EAST ROSWELL LIBRARY
ADDENDUM NO. 23.1-2
APRIL 22, 2013

This Addendum No. 23.1-2 dated April 22, 2013 issued by Ajax Building Corporation of Georgia is hereby made part of Bid Package 23.1 – HVAC & CONTROLS for the East Roswell Library. The changes and/or clarifications included in this Addendum shall be considered as part of the Bidding Documents and shall supersede, amend, add to, or subtract from those conditions included in the original Bidding Documents, including the Project Bid Package, Drawings, Specifications, previous Addenda, etc. This Addendum must be acknowledged in the space provided on the Proposal Form (included in Section II of the Bid Package). Failure to acknowledge this Addendum may subject Bidder to disqualification.

KHAFRA Project Number 11ATL06

ADDENDUM NUMBER ONE

UTILITY PLAN

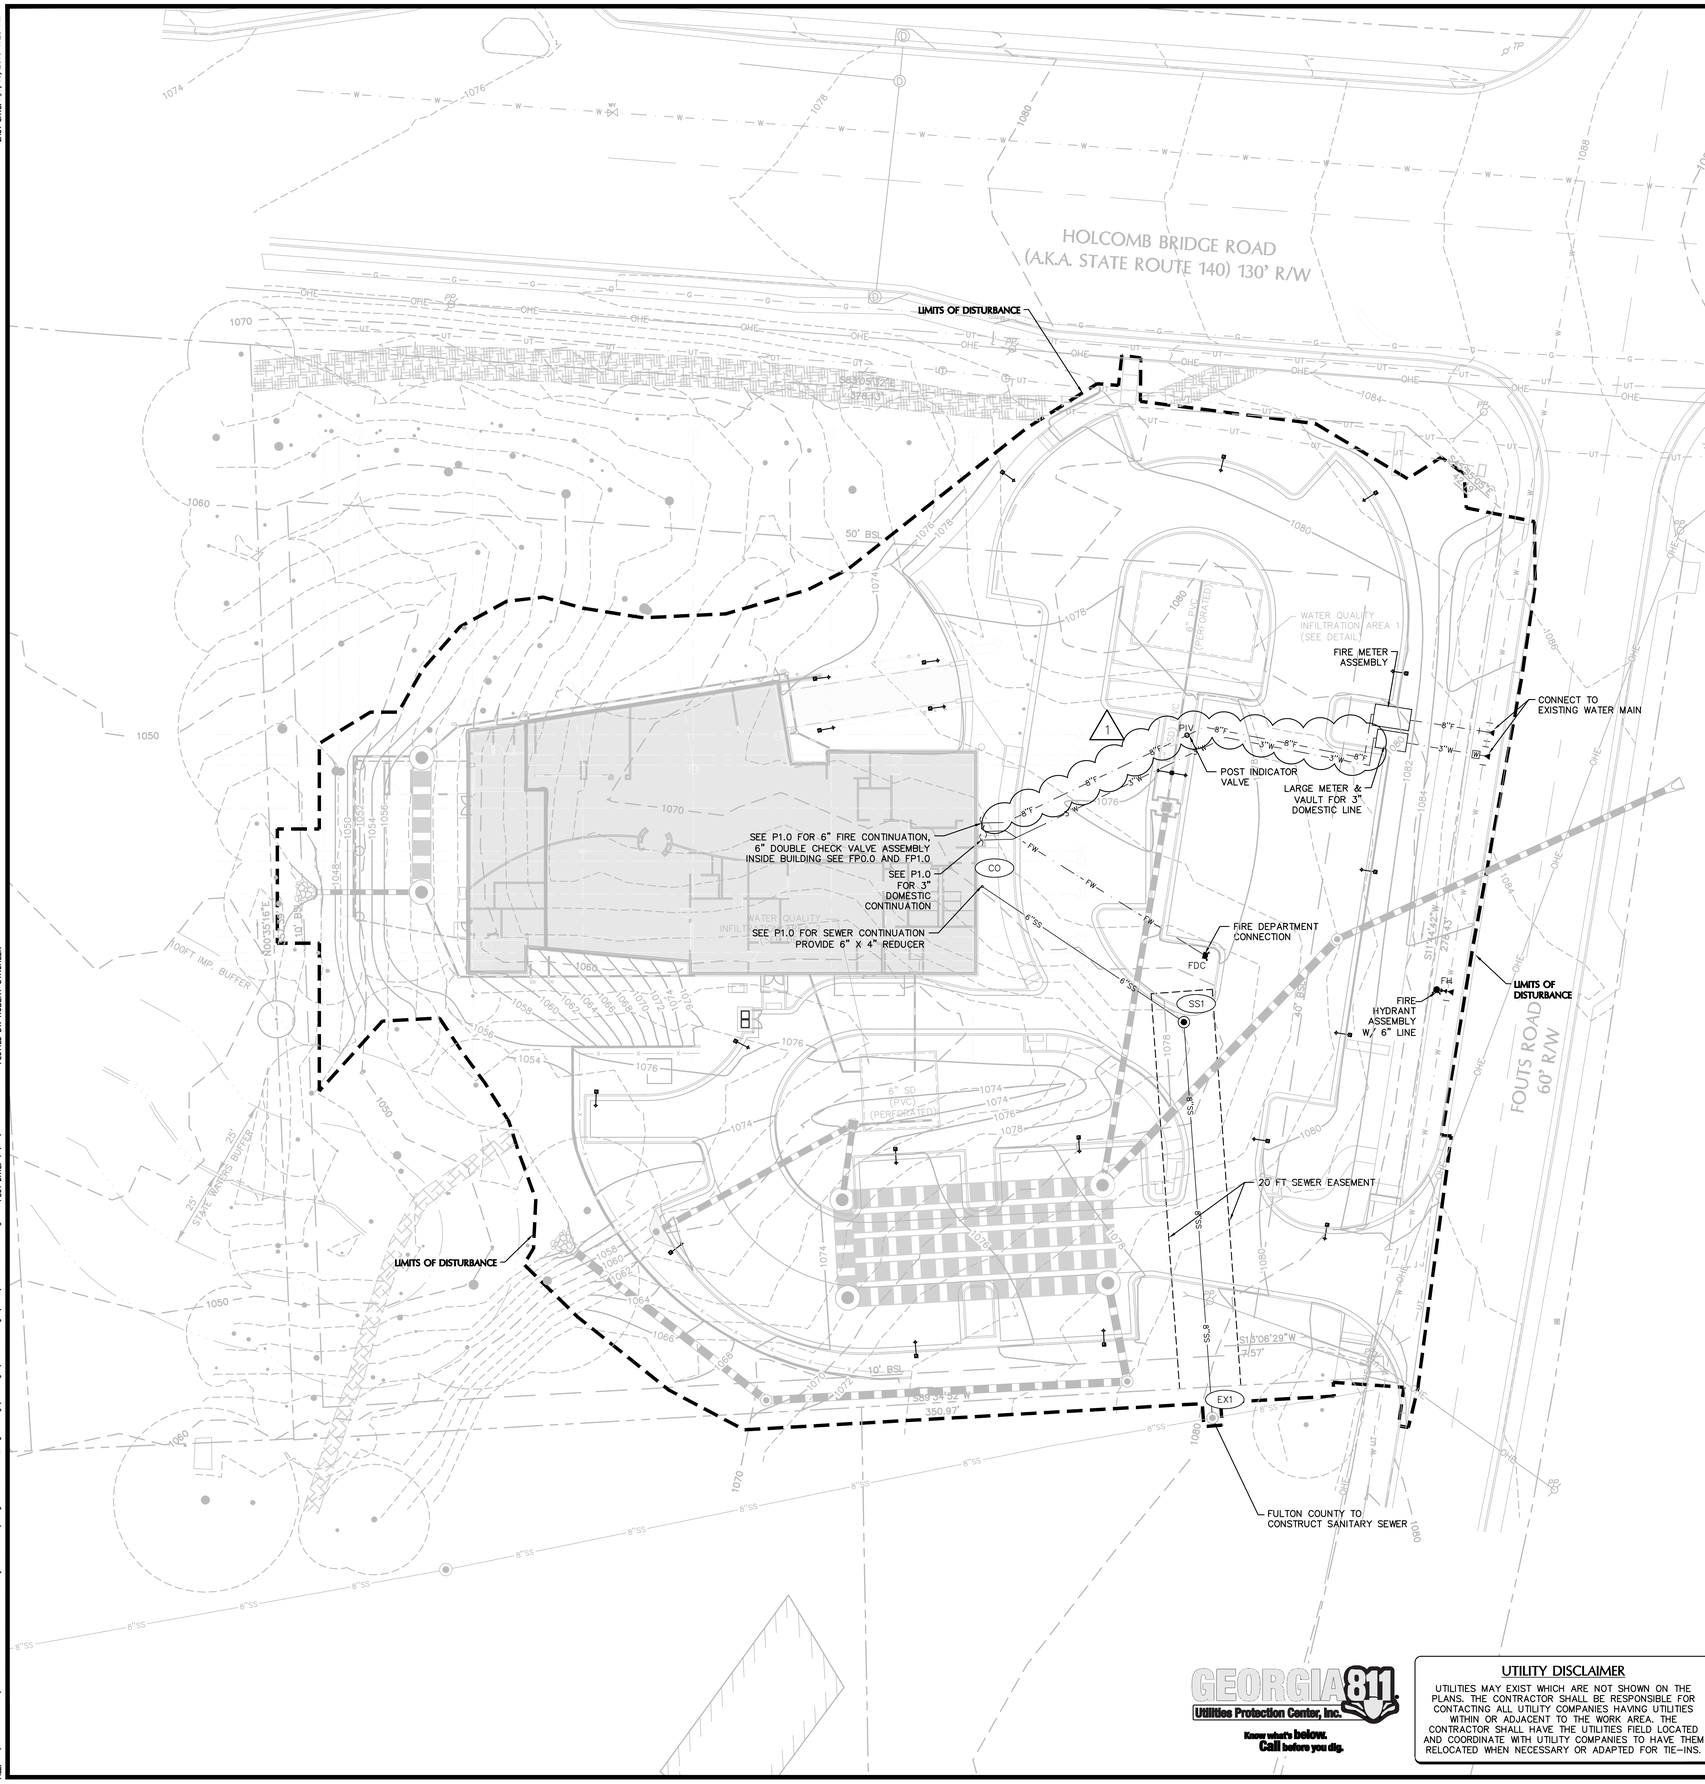
1. The following sheets are issued herewith:
   a. C-500 Utility: delete the sheet and replace with the attached sheet. The fire line between the fire meter assembly and the building has been upsized from a 6-inch line to an 8-inch line.
   b. FP0-0 - Fire Protection Legend, Schedule and Details: delete the sheet and replace with the attached sheet. Detail 4 – Added a 6" tag to the outgoing line on the Double Check Valve Assemblies Detail, DCVA, and changed the incoming fire line size from 6" to 8" on the same detail.

1 BASEMENT FLOOR PLAN - FIRE PROTECTION
1/8" = 1'-0"

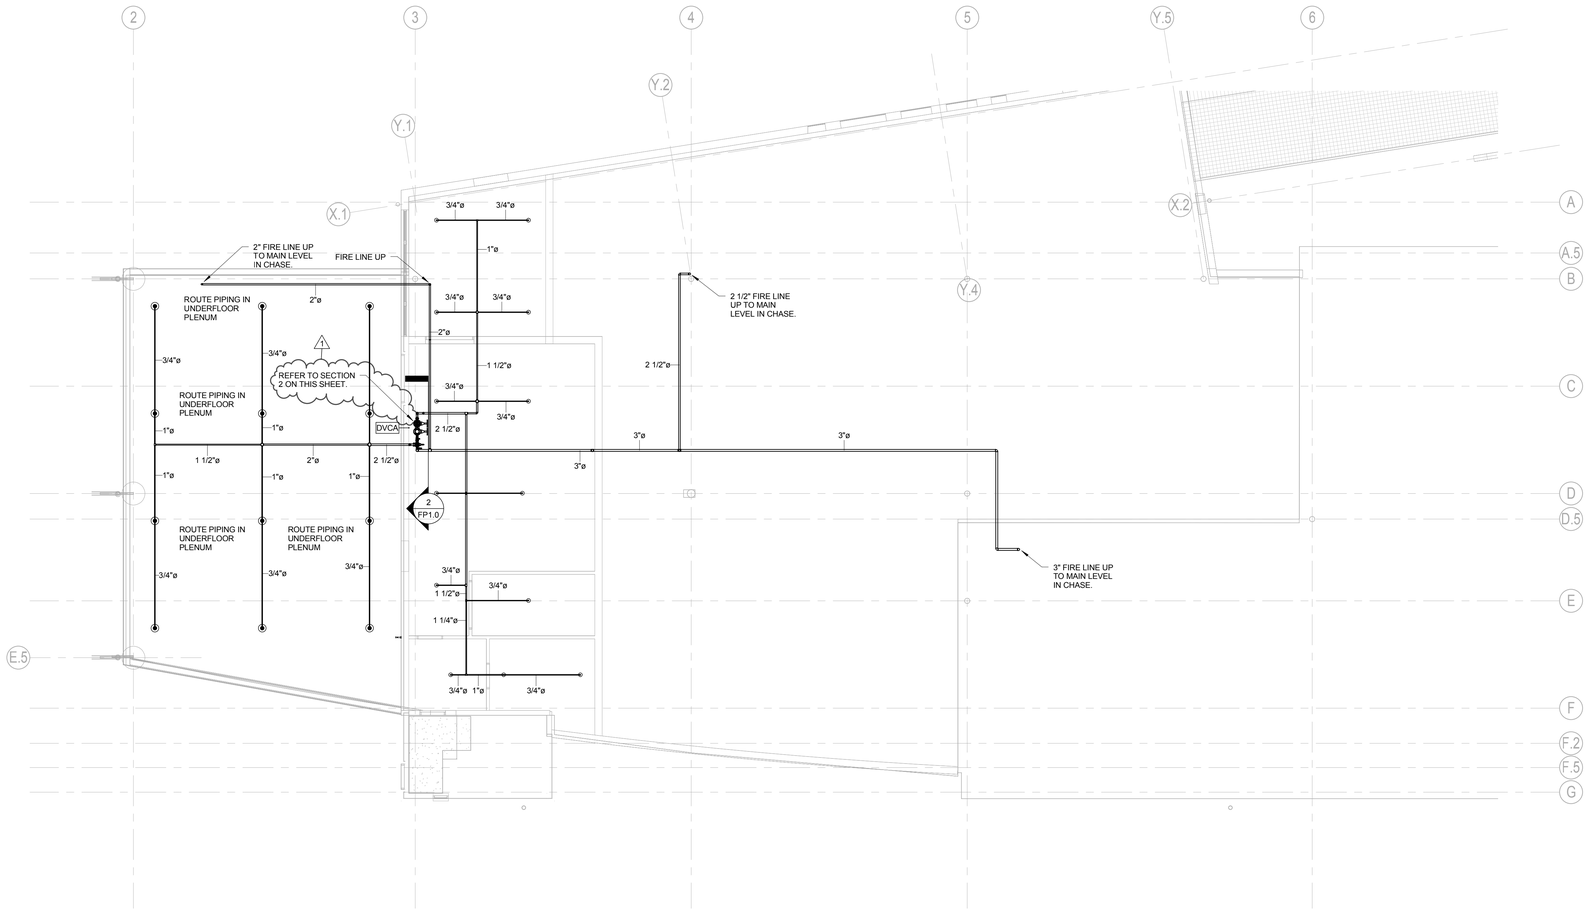
c. FP1-0 - Basement Floor Plan - Fire Protection: delete the sheet and replace with the attached sheet. Plan - Changed the note pointing to the DCVA to read as follows: "Refer to Section 2 This Sheet."
